We are working on cases related to droplet impingement and we would like to count on your support to clarify the aspects below:

1- Regarding case 121, experimental data presented in file "IPW1-case-descriptions-20210318.pdf", slide 9 are related to which vertical section of airfoil?

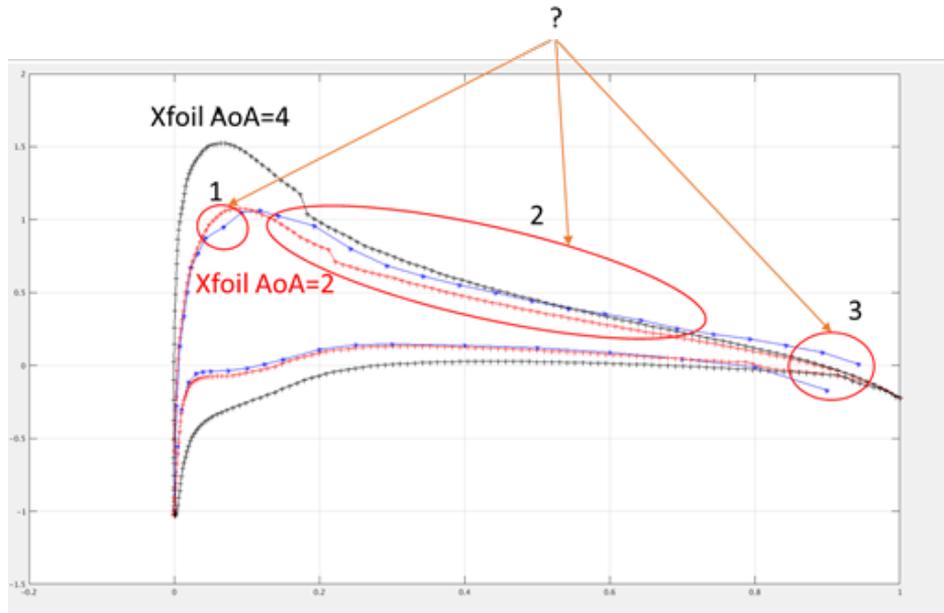
The Cp distribution in the suction side (and the last point before the TE in the pressure side), seems still quite "weird" when compared with other experimental CP available in the literature or when compared with numerical simulations. I will use the distribution predicted with xfoil, to help me out in describing what I think is "weird" (see picture below).

I see 3 problems in the experimental CP that would need an explanation:

1. Close to the LE there is a discontinuity in the CP. Is that measurement error or there is a physical explanation?
2. the suction side (from 0.2 X/c to the TE) the pressure is really low (e.g., I get that values for AoA around 4 deg).
3. Something is happening, either at the pressure side or at the suction side, at the TE.

Do you think it exists a report on these measurements? Could you get more information?

1. This discontinuity is most likely some type of measurement error resulting from some issue with the pressure tap or tubing leading to the transducer. The model itself could be considered high fidelity (CNC machined), so this was not likely to be caused by some local surface defect.
2. It looks like XFOIL is suggesting boundary layer transition occurs near $x/c = 0.2$. Unfortunately, the experimental C_p data do not have sufficient spatial resolution to determine the transition location. So there could be some mismatch of transition location that is affecting the comparison.
3. I agree that the experimental C_p in this region are not well behaved. I would attribute this to measurement uncertainty and potential problems with the pressure tap or tubing leading to the transducer.

General comment: I have seen surface pressure data from the IRT over the course of nearly 20 years and it typically has these kinds of issues. Part of the problem is that the test articles are constantly subjected to cold and wet conditions which ultimately degrade the pressure taps and internal tubing, despite efforts to cover the taps and protect the tubing. Also, the pressure measurement system at IRT does not offer optimal full-scale ranges for surface pressure that is typically found in aerodynamic wind tunnels. For example, the magnitude of the trailing edge

pressures are very low, but these are measured on the same transducer full-scale range as the leading edge pressures. One outcome of this workshop could be to make recommendations for higher accuracy surface pressure data and why that is needed for more accurate ice prediction.
